**ALTREA, LLC.**

March 6, 2007

**RE: Revised Work Plan for Subsurface Investigation of Below-Ground Hydraulic Elevator Unit, 7200 Johnson Drive, Pleasanton, CA**

**FIGURE 1:  
Plan View of Basement of Building No. 3  
Clorox Services Facility  
7200 Johnson Drive  
Pleasanton, CA 94588**

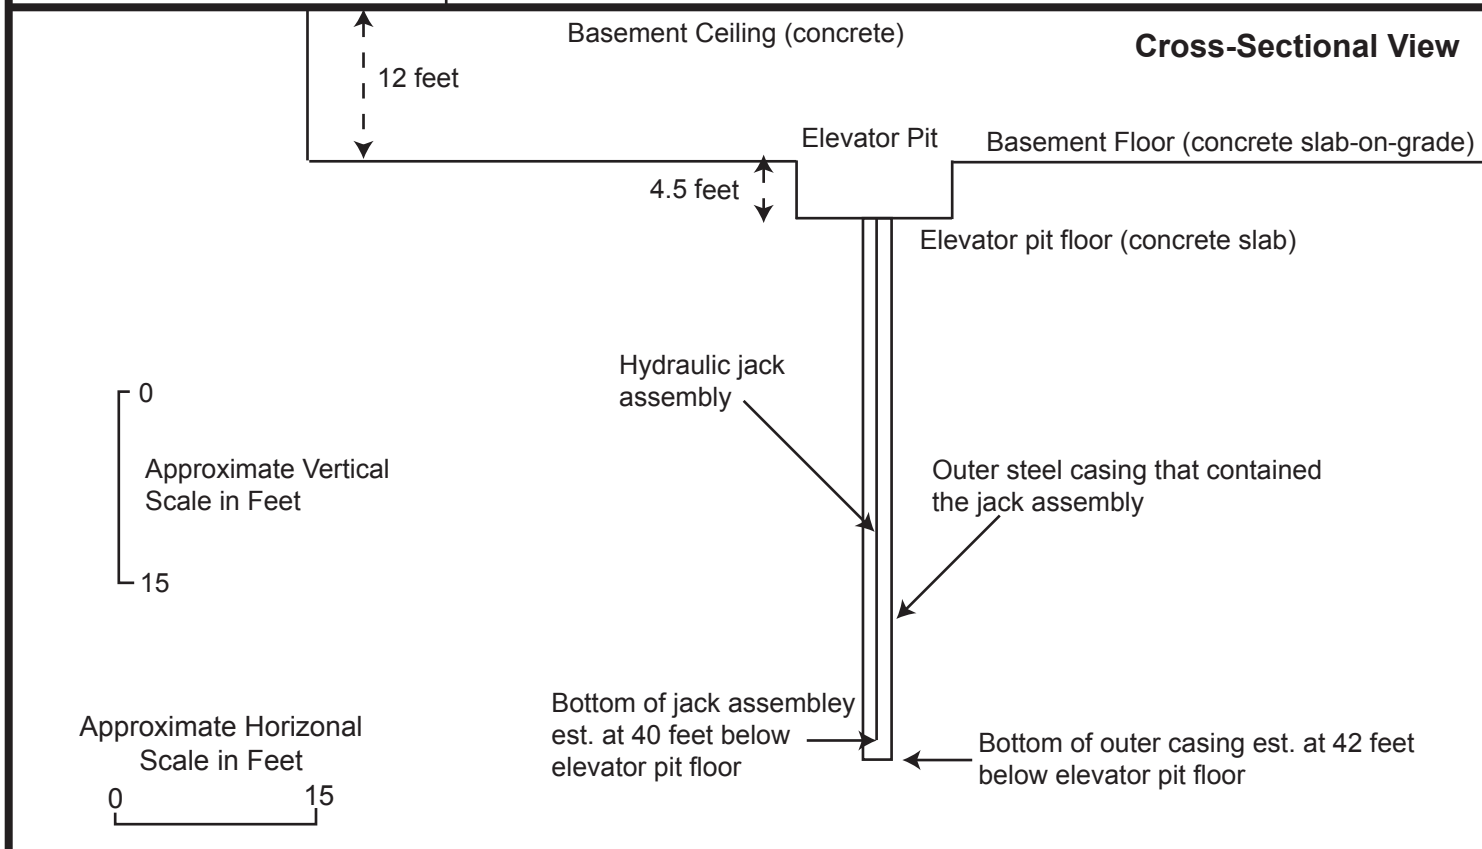
The attached **Figure 1** presents the location of the freight elevator subject of the investigation. Altea proposes to collect soil and groundwater samples in the vicinity of the former below-grade, steel encased hydraulic elevator jack assembly, submit soil and groundwater samples for laboratory analyses for hydraulic oil-range petroleum hydrocarbons, and prepare a technical report on the investigation results.

**Figure 1** shows the location of the hydraulic elevator system. The hydraulic elevator system is currently not in operation. In December 2006, TKE drained the hydraulic oil from the system, locked the elevator cab in place, and removed the below-ground jack assembly (Altreia, December 18, 2006). Also in December 2006, the drilling contractor (McRae, Inc.) drilled out the sand and pumped out groundwater from the outer steel casing that was left in-situ below the elevator pit. A temporary plug was placed on the exposed top of the steel casing and the area was secured.

<p>ALTREA LLC P. O. Box 255251 Sacramento, CA 95865</p>	<p>Clorox Services Facility 7200 Johnson Drive Pleasanton, CA</p>	<p><b>Figure 2:</b> <b>Plan View and Cross-Sectional View of</b> <b>Elevator Pit Area in Basement</b> <b>Building No. 3</b></p>
	<p>February 2007</p>

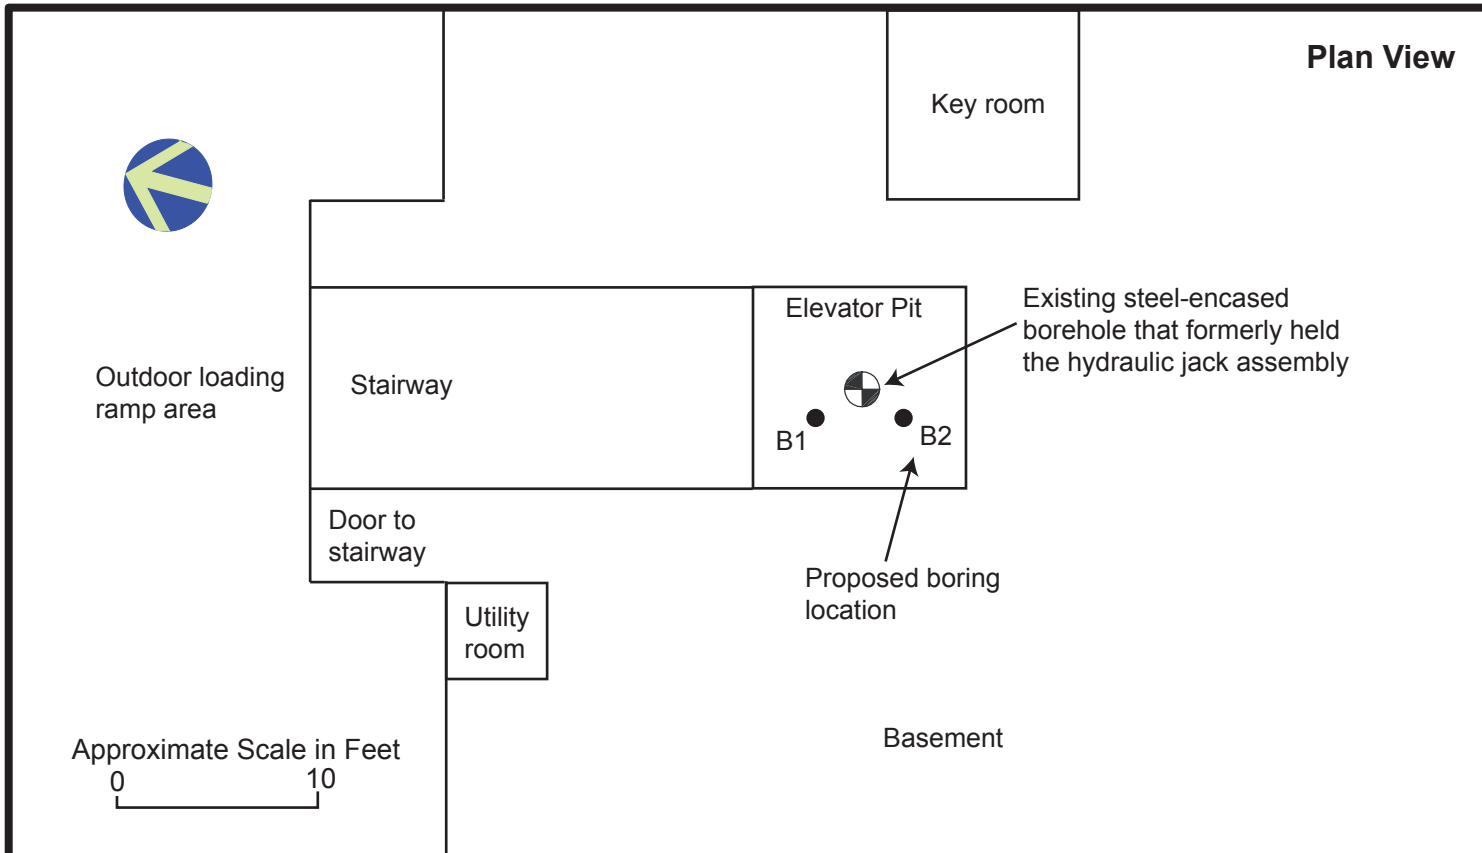
**Figure 2** is a plan view and cross-sectional view of the elevator pit area in the basement of Building No. 3. The figure presents a preliminary schematic of the jack assembly and outer steel casing, as requested in your letter of February 13, 2007. **Figure 2** also presents the proposed boring locations.

- 
- Altreia proposes to drill two (2) boring locations in the elevator pit (**Figure 2**). These borings (B1 and B2) will be drilled in the cored holes described above for access to the subsurface soil materials. These borings will be drilled utilizing portable, continuous-flight hollow-stem auger equipment to be installed in the elevator pit. The diameter of the borings will be approximately 6.5 inches in diameter. An attempt will be made to advance each boring to maximum depth of approximately forty-two (42) feet below the elevator pit floor. A soil sampler consisting of a hollow steel cylinder approximately two (2) feet long and 1.5-inch diameter will be used to retrieve soil samples. The sampler will be loaded with retractable steel sleeves that will contain the soil samples. After advancing the auger flight to the desired sampling depth, the soil sampler will be driven by percussion approximately two (2) feet into the undisturbed soil at the base of the auger flight. The sampler will be retrieved and the geologist will inspect the soil sleeve samples using the Unified Soil Classification System. The soil will be field screened with a portable photo-ionization detector (PID). A selection of soil samples will be collected from each boring for submittal for laboratory analyses. The soil sampler will be cleaned and decontaminated, and loaded with a new set of inner sleeves for the next sampling interval. The borehole will be advanced to the next sampling depth and the soil sampling process repeated. Starting at the base of the elevator pit slab, Altreia plans to collect soil samples at approximately four (4) feet depth intervals for purposes of field inspection and screening. However, Altreia will attempt to perform continuous soil sampling in the 26 to 30 feet depth interval, around the 28-foot depth where the alleged oil leak in the jack assembly occurred.
